**CITY OF LA VISTA
MAYOR AND CITY COUNCIL REPORT
SEPTEMBER 18, 2018 AGENDA**

Subject:	Type:	Submitted By:
APPLICATION FOR PUD SITE PLAN – LOT 1, ROTELLA’S FIRST ADDITION, LOTS 4, 5, 6, 15, 16, 17, AND 28A OAKDALE PARK, AND TAX LOT 8A2 (108 TH ST & HARRISON ST)	◆ RESOLUTION ◆ ORDINANCE RECEIVE/FILE	CHRISTOPHER SOLBERG CITY PLANNER

RE: Rotella's Italian Bakery
Site Development Plan
Proposed Planned Unit Development (PUD) Site Plan - Initial Review

RE: Rotella's Italian Bakery
Site Development Plan
Proposed Planned Unit Development (PUD) Site Plan – 2nd Review

SITE SETBACKS PLAN

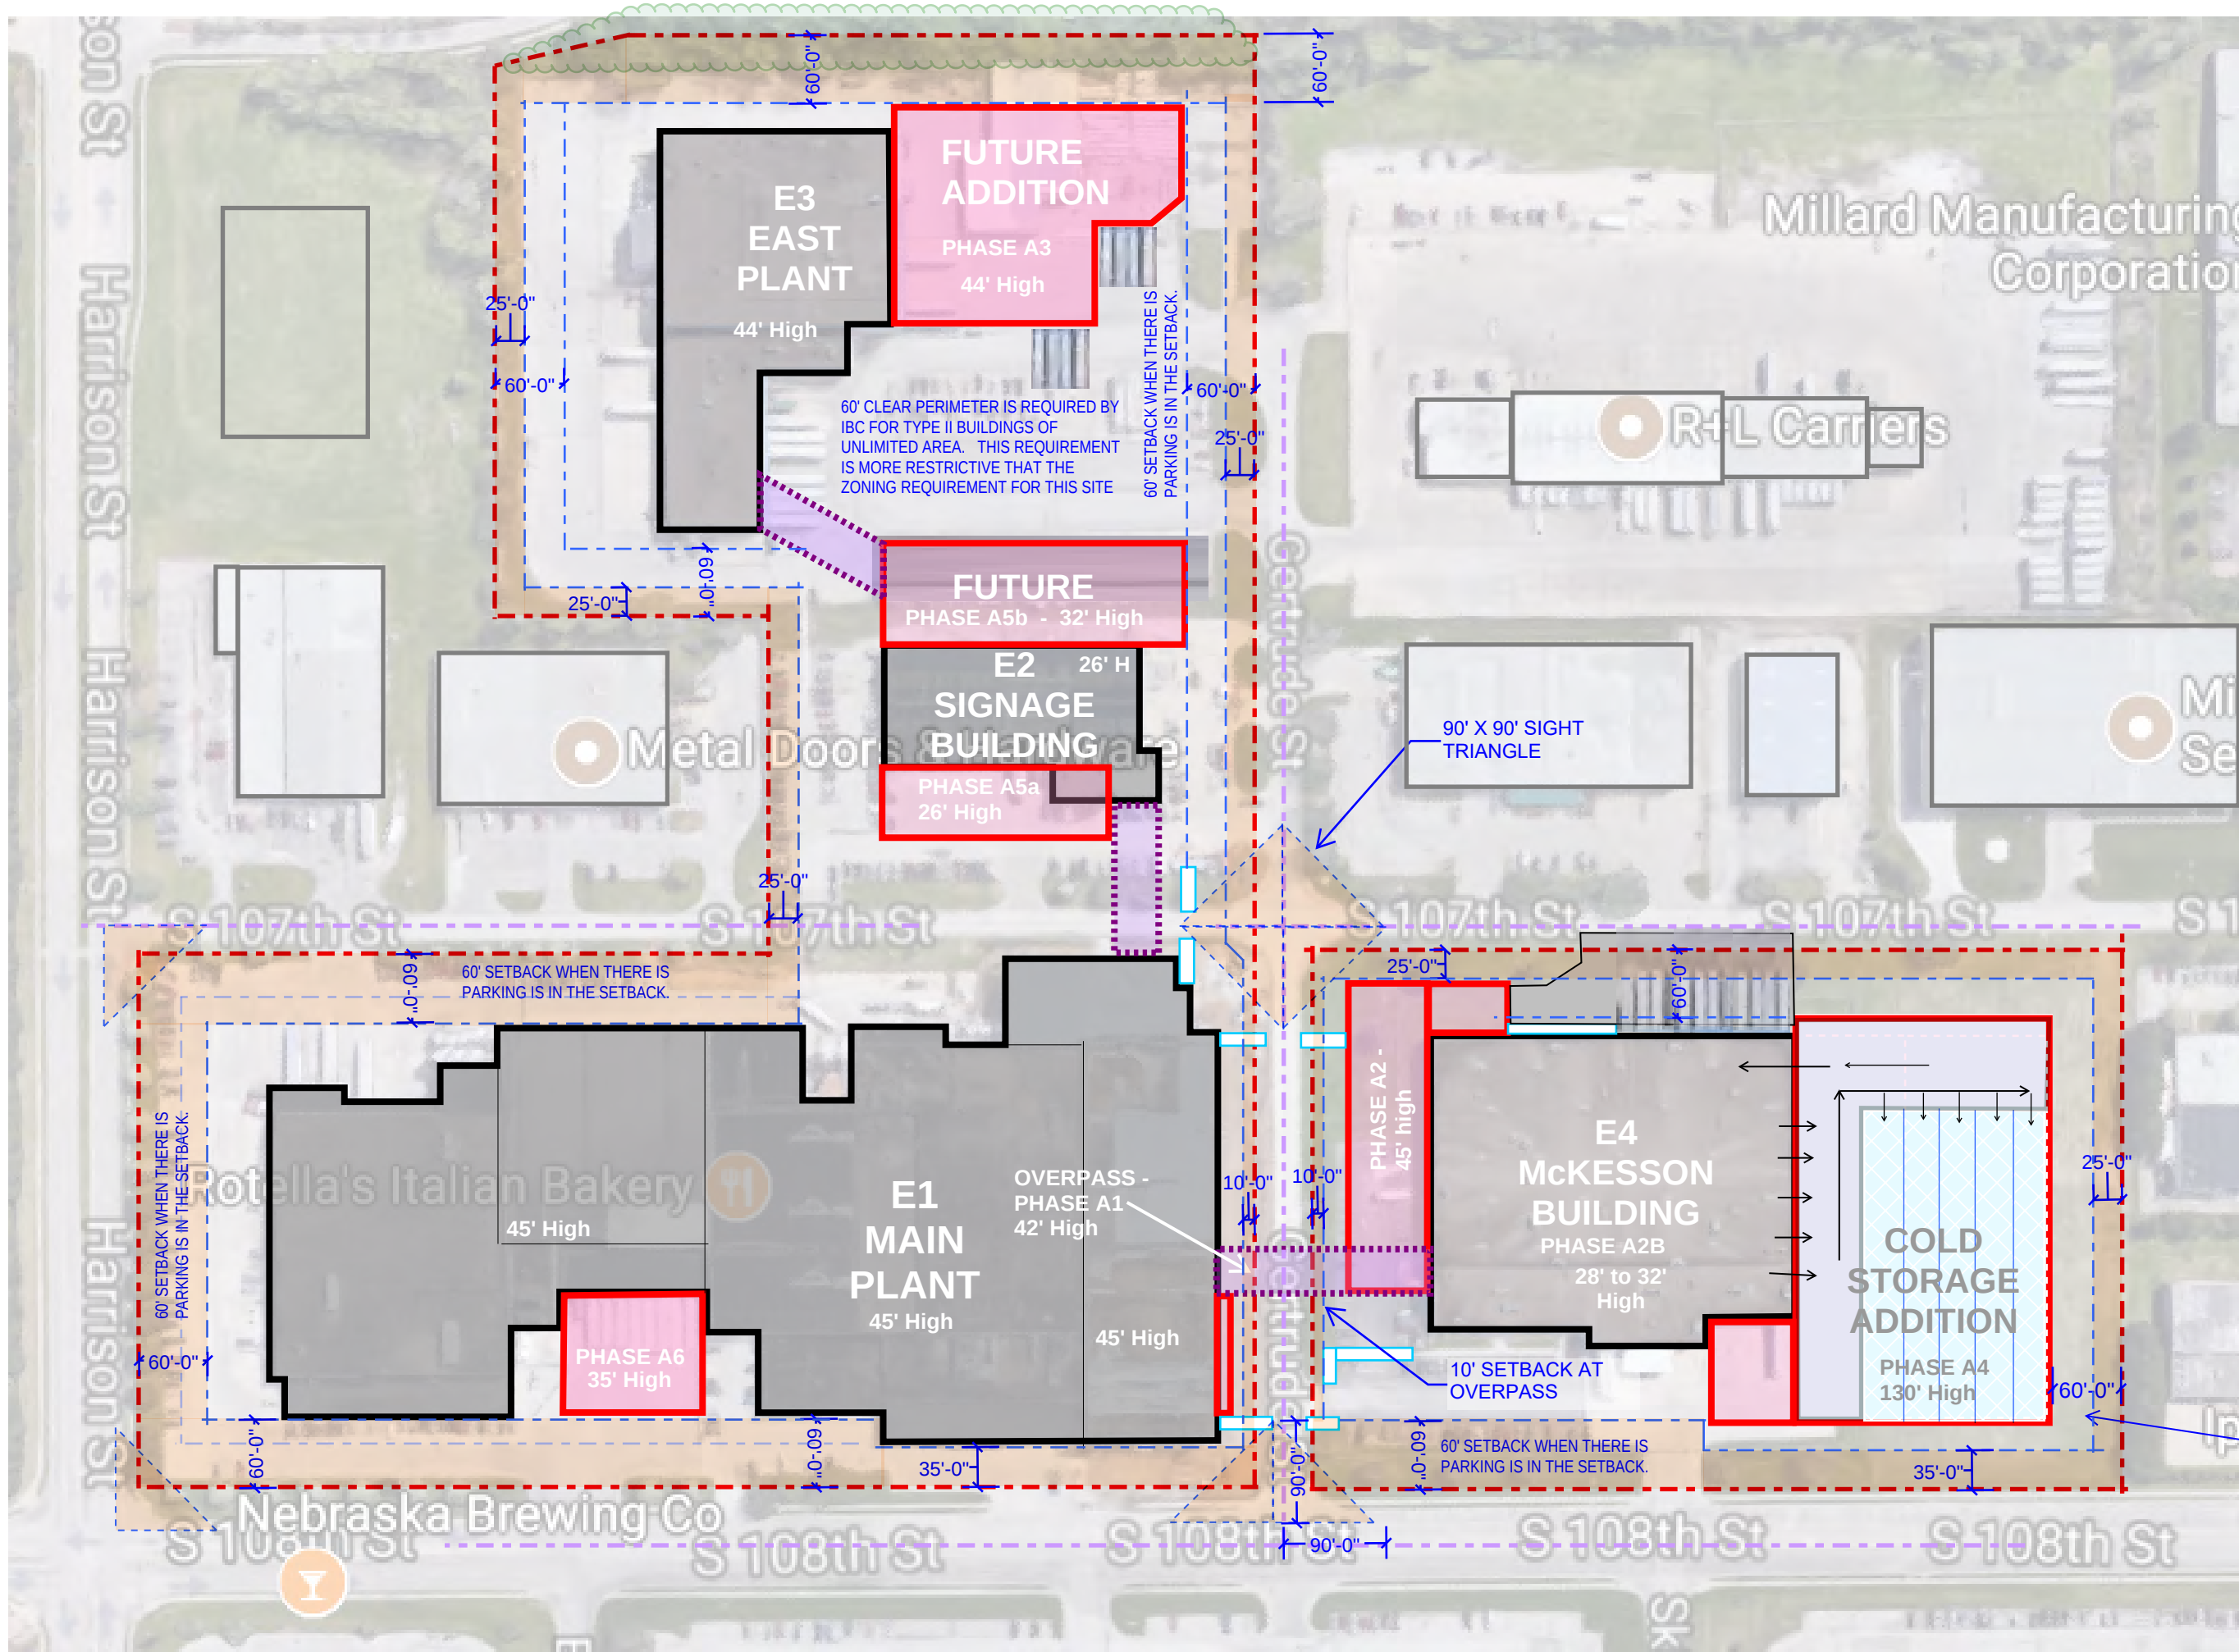
10. Article 5.15.04.09: The Site Plan, Attachment 2, needs to identify the locations and amount of exceptions to setbacks and heights. Additionally, #2 in the Rear setbacks section should be removed as the City does not regulate parking and paving through setbacks. This is completed through the landscaping requirements in Section 7.17. Specifically regarding Table 4, the PUD cannot attribute setbacks based on ownership. Setbacks should be depicted through the PUD site plan. The proposed maximum height allowed of 130-feet is currently under further review.

- 10) **Item 10** - [article 5.15.04.09] – Site plan (attachment 2)
- a. **Depiction of setbacks**
- i) **Comment:** Request that setbacks and heights be depicted via the Site Plan (currently listed in Table 4).

- ii) **Response:** Indication of zoning setbacks have been added graphically to the site plan. See **attached Site Setback plan.**
- b. **Parking noted in Table 4**

FIRE HYDRANT LOCATION PLAN
EXISTING & NEW LIGHT POLES

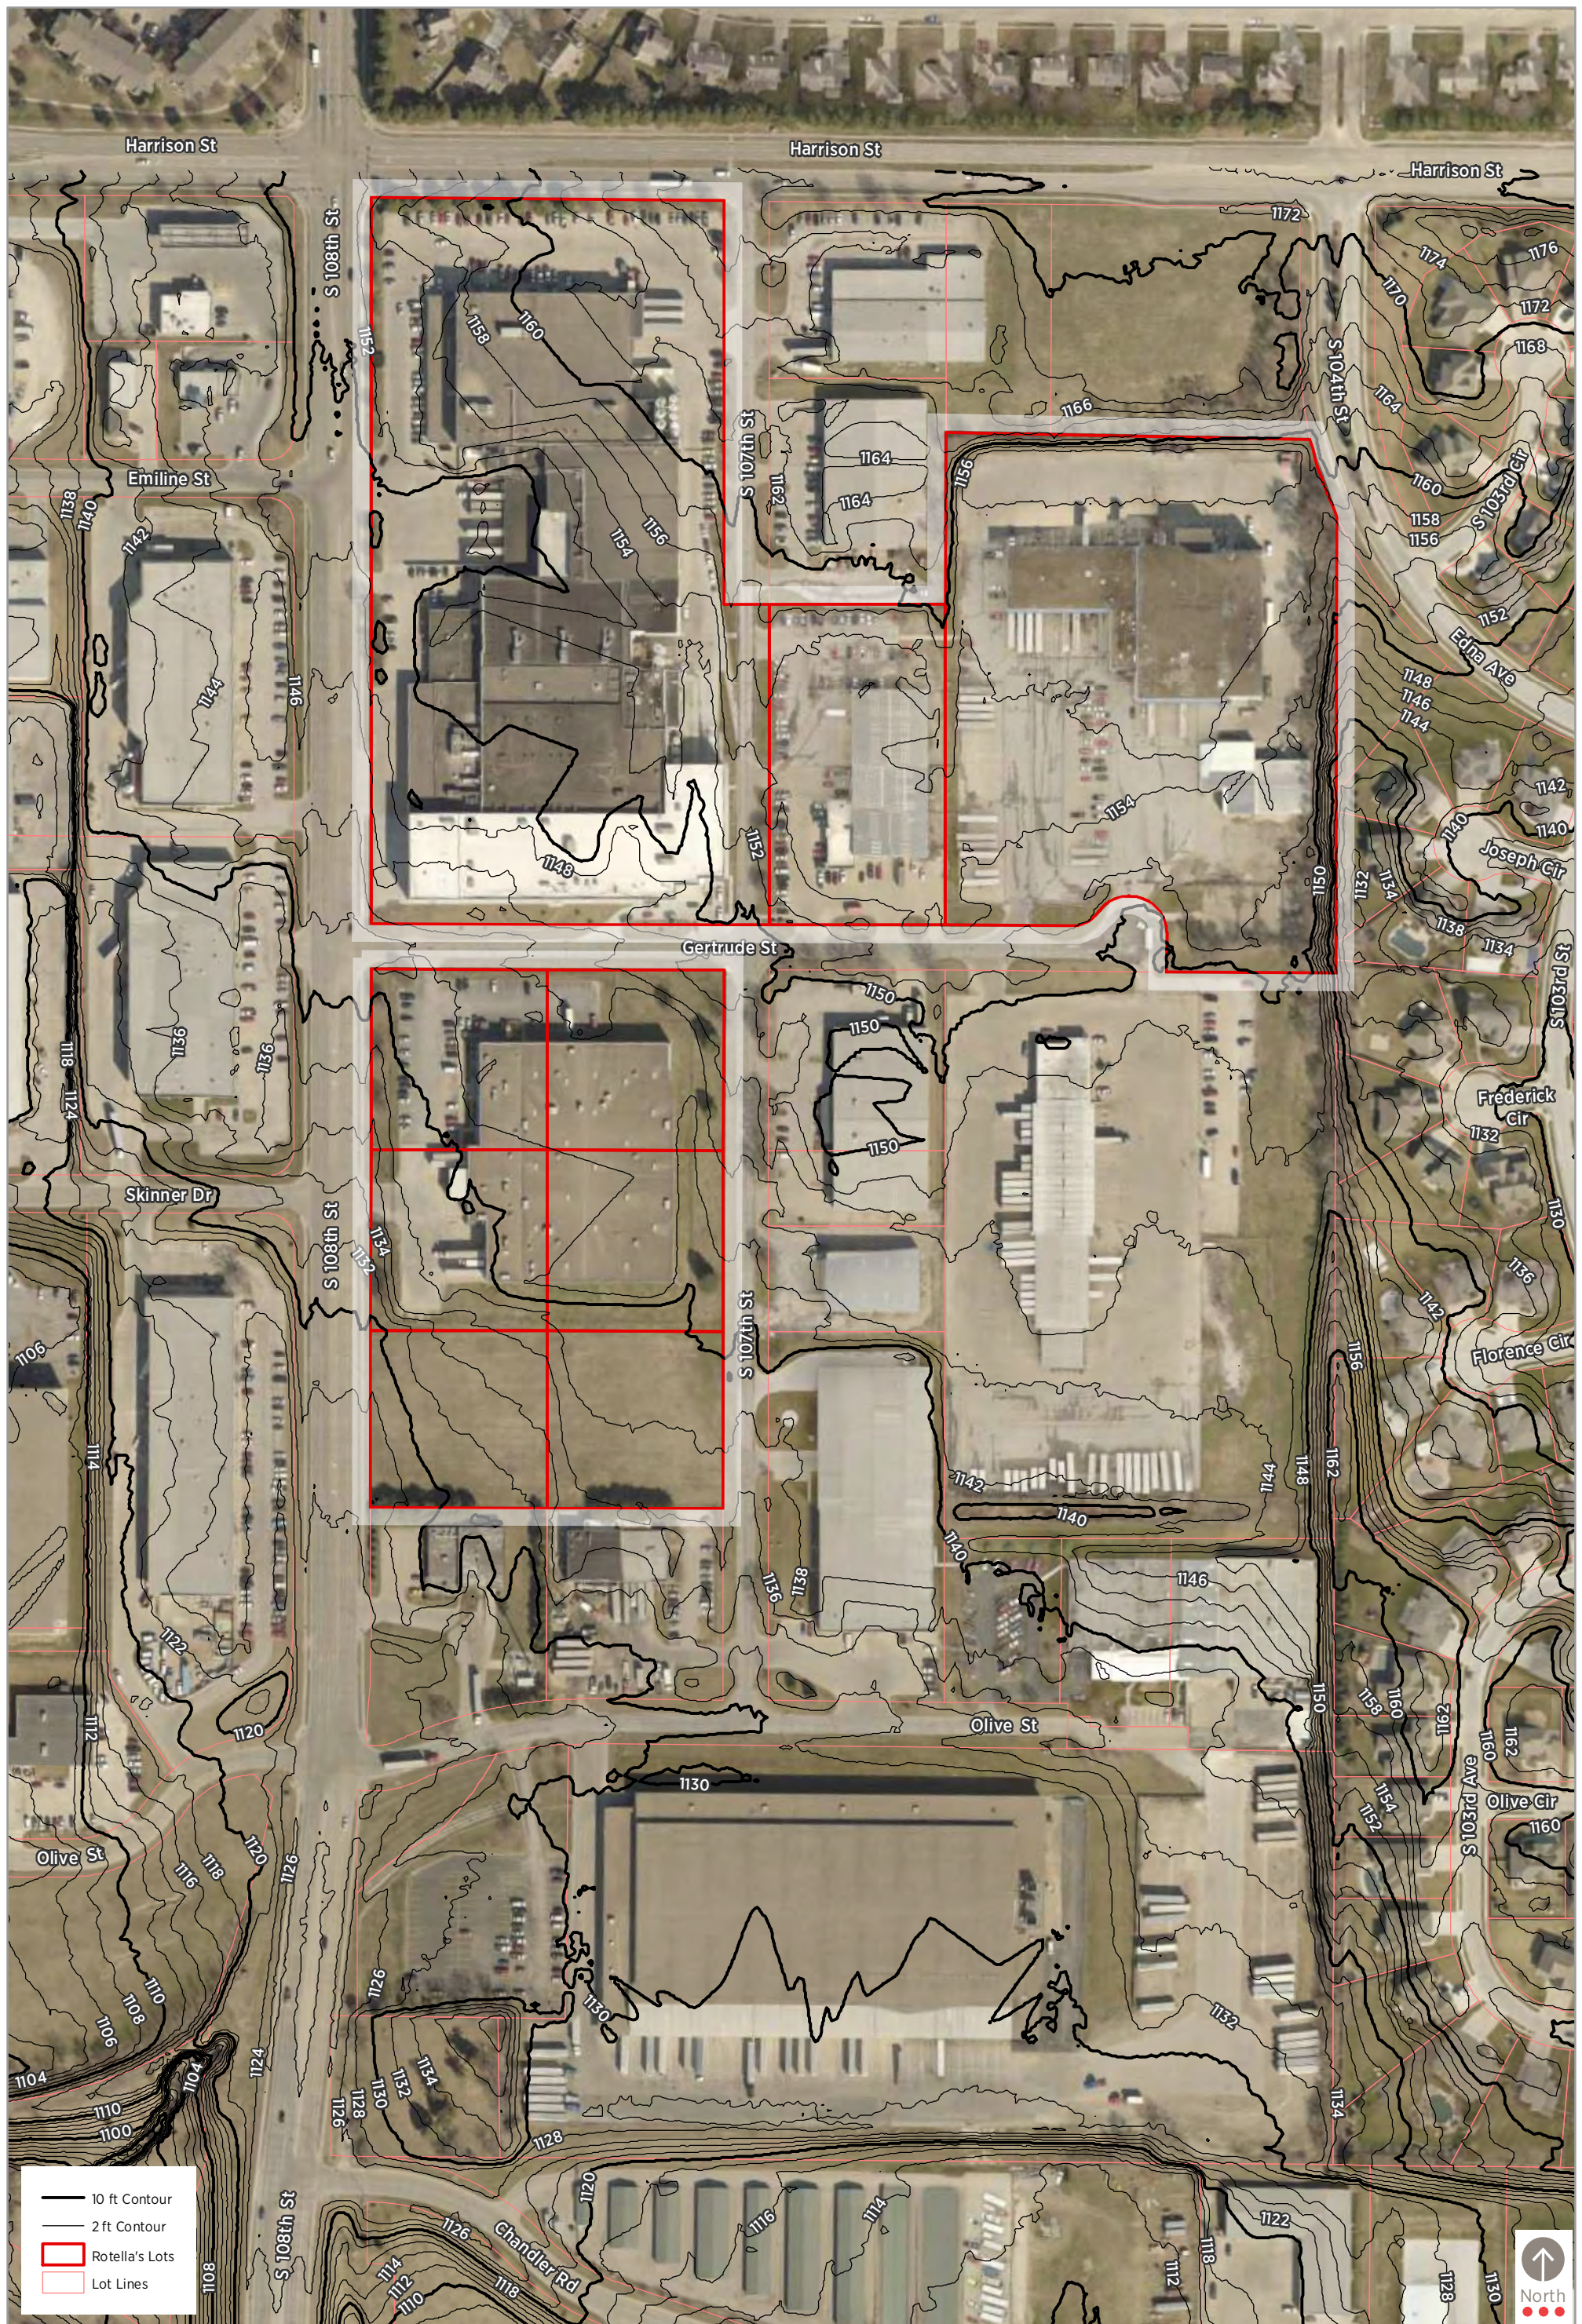
- i) Comment: Additional information requested about Lighting, Noise, and Building height.
- ii) Response:
 - (1) Lighting: As noted in the tabular recap of Zoning section 5,14 & 5.15, part 5.15.04.21: Site lighting will be located on poles and aimed back at the building to minimize light spillage onto adjoining properties. A schematic layout of light pole locations have been added to the site utility plan.
